PROJECT NAME: GARRISON ROAD INDUSTRIAL PETITION NO: **PETITIONER:** PLANS PREPARED BY:

PROJECT NAME: GARRISON ROAD INDUSTRIAL ⁻4 2019-173 **PETITION NO: PETITIONER:** MCCRANEY PROPERTY COMPANY **PLANS PREPARED BY:**

- **a. Site Location**. These Development Standards, Schematic Site Plan and other graphics set forth on Sheet RZ-1 and any other Sheets form this rezoning plan (collectively referred to as the "Rezoning Plan") associated with the Rezoning Petition filed by McCraney Property Company ("Petitioner") to accommodate the development of the requested permitted uses on the approximately 150 acre site located on Garrison Road (the "Site").

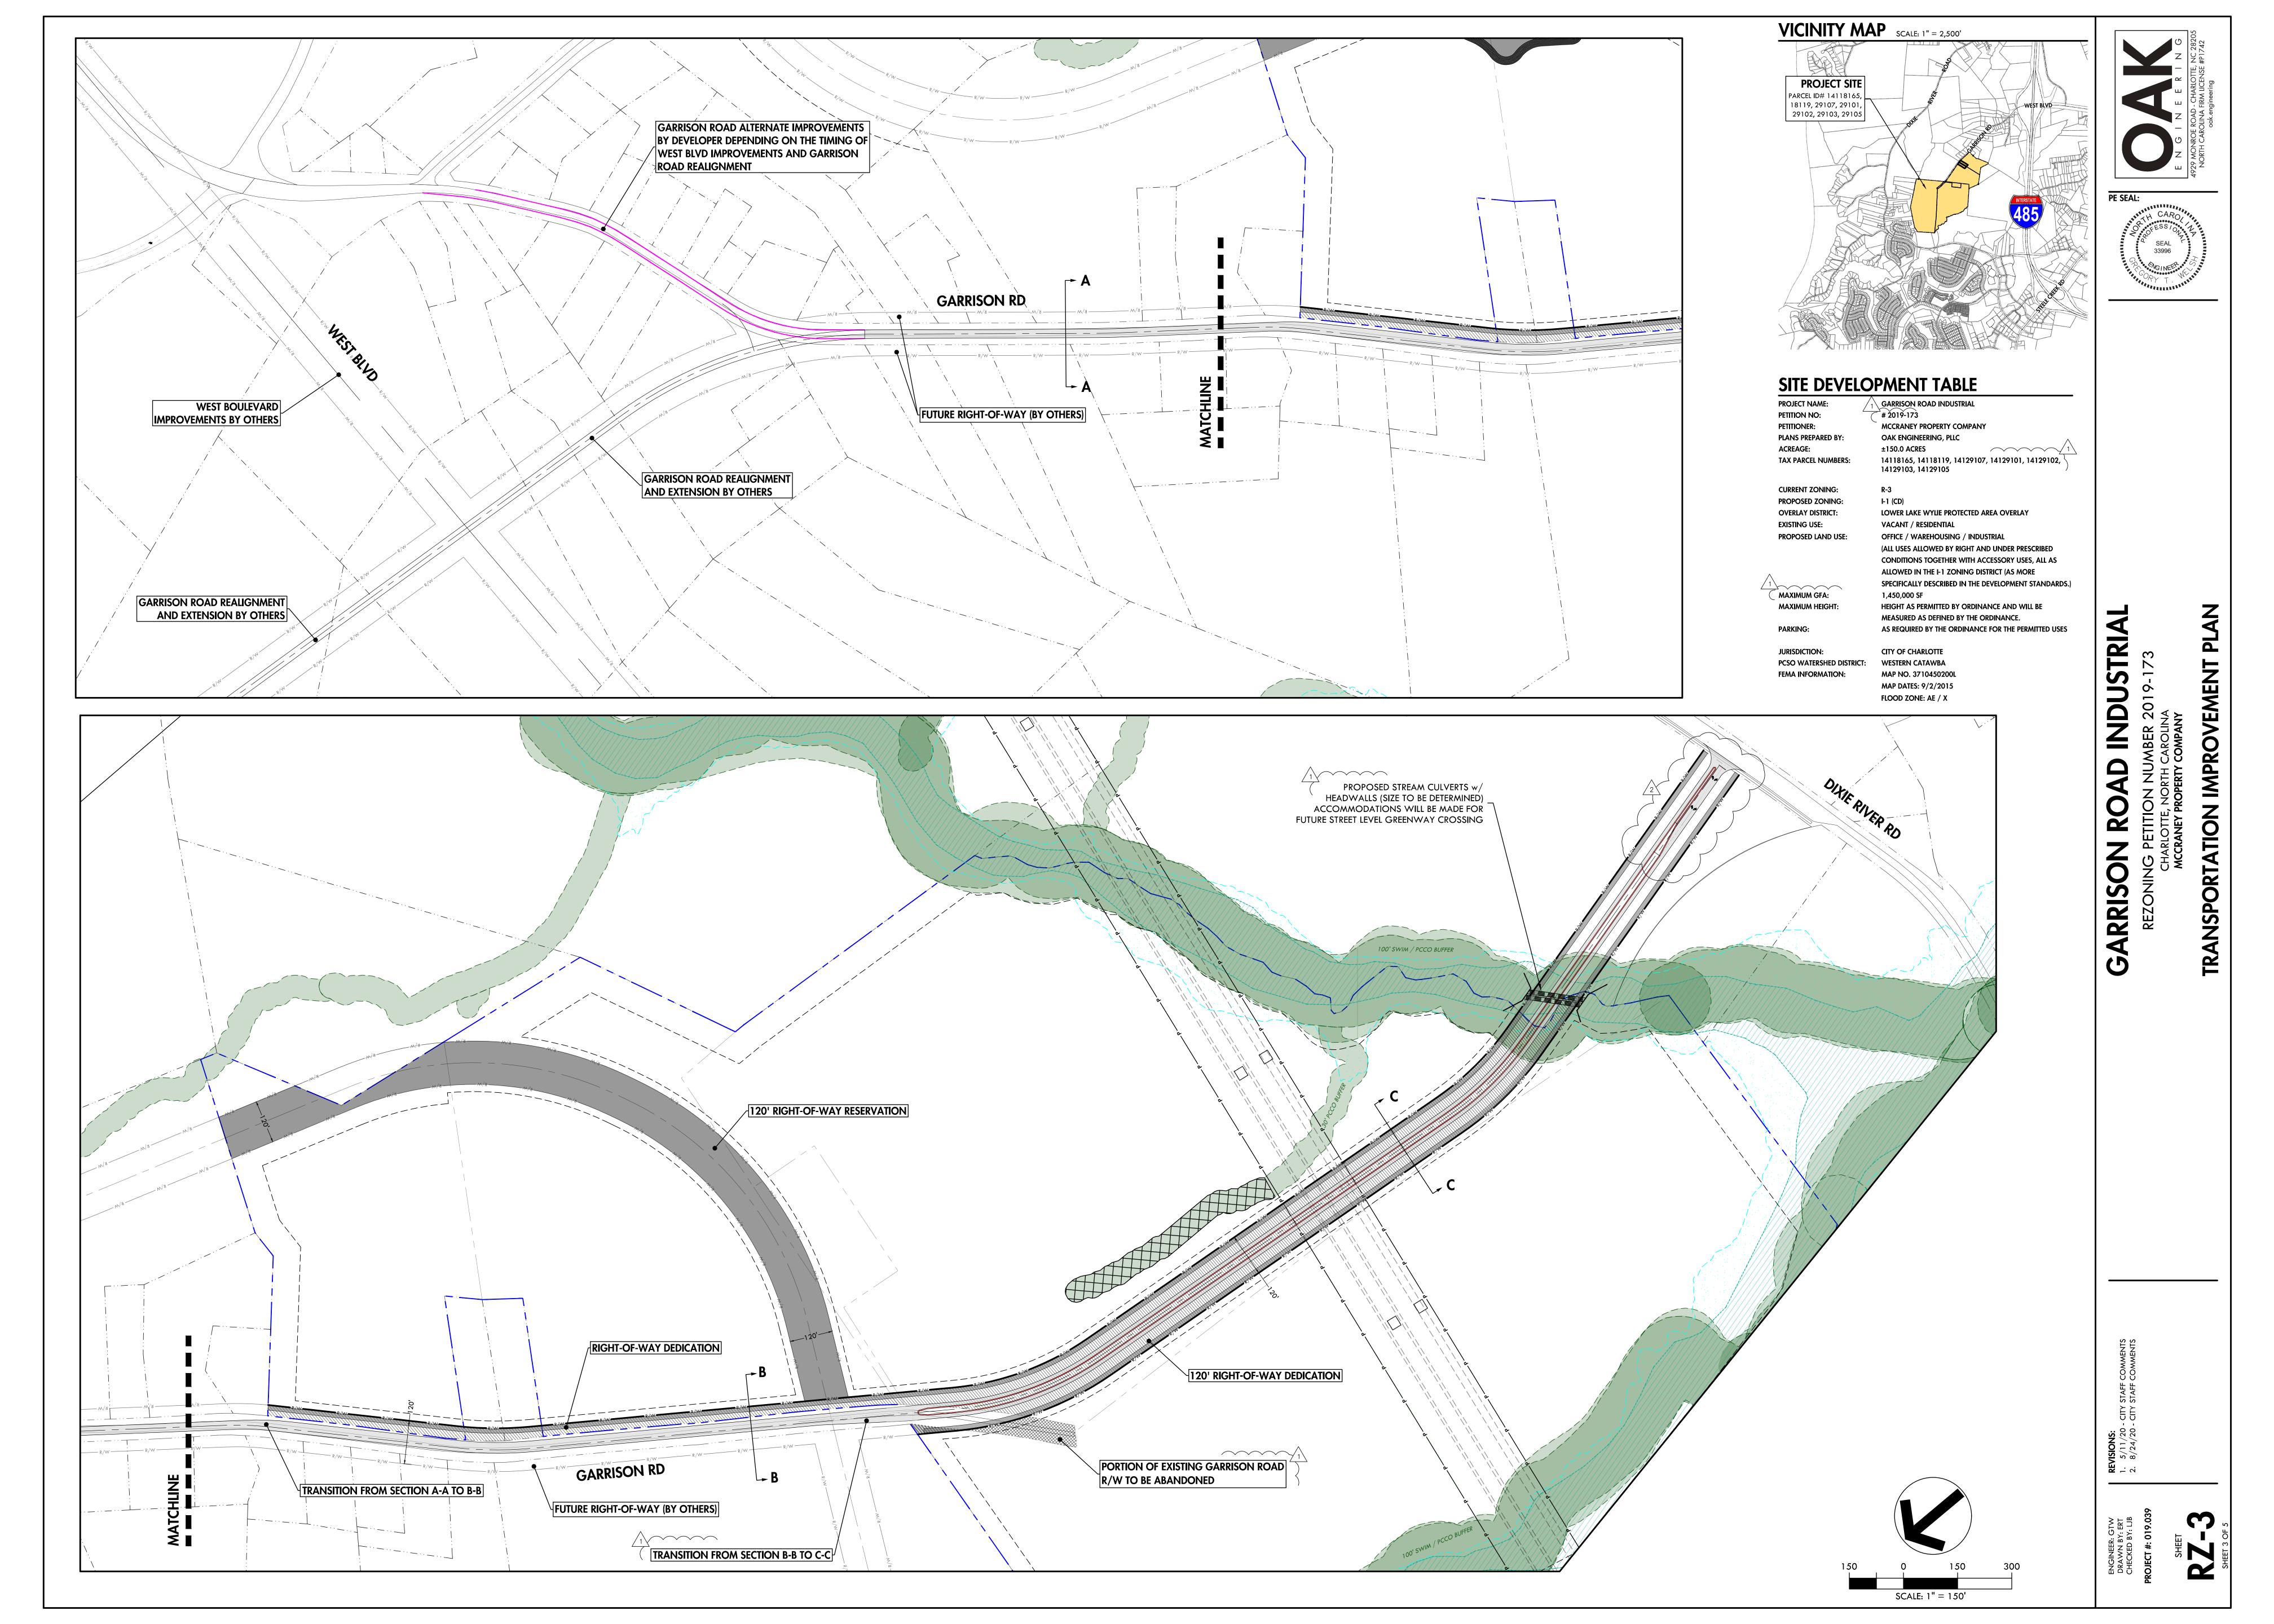
revised. It's a 100' considered a multidistrict per the buffer section of Chapt. 12 of the Zoning Ordinance Petition 2001-030 does not permit non-residential or adjacent MX-1

This needs to be
